Bulbourne Yard - Building 3, North Elevation
Investigation of façade masonry
30 November 2019

Hutton + Rostron Environmental Investigations Ltd
Netley House, Gomshall, Surrey, GU5 9QA Tel: 01483 203221 Fax: 01483 202911
150.90 Site Note 3 -Not to scale- © Copyright Hutton+Rostron 2019

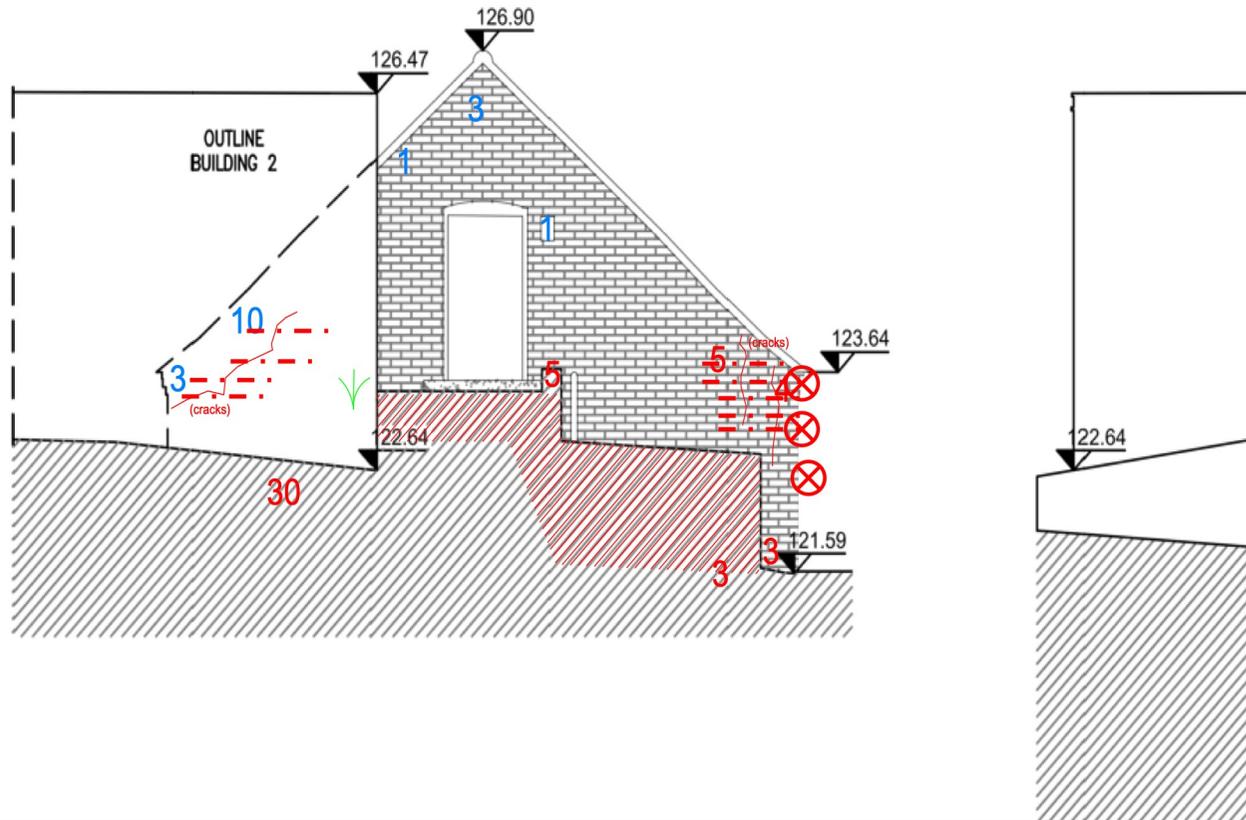
Helibar as CS05 cross stitch with dry fix where they can not be lapped by 500mm, Cemtie No 4 fracture from the West elevation at 300c/c.
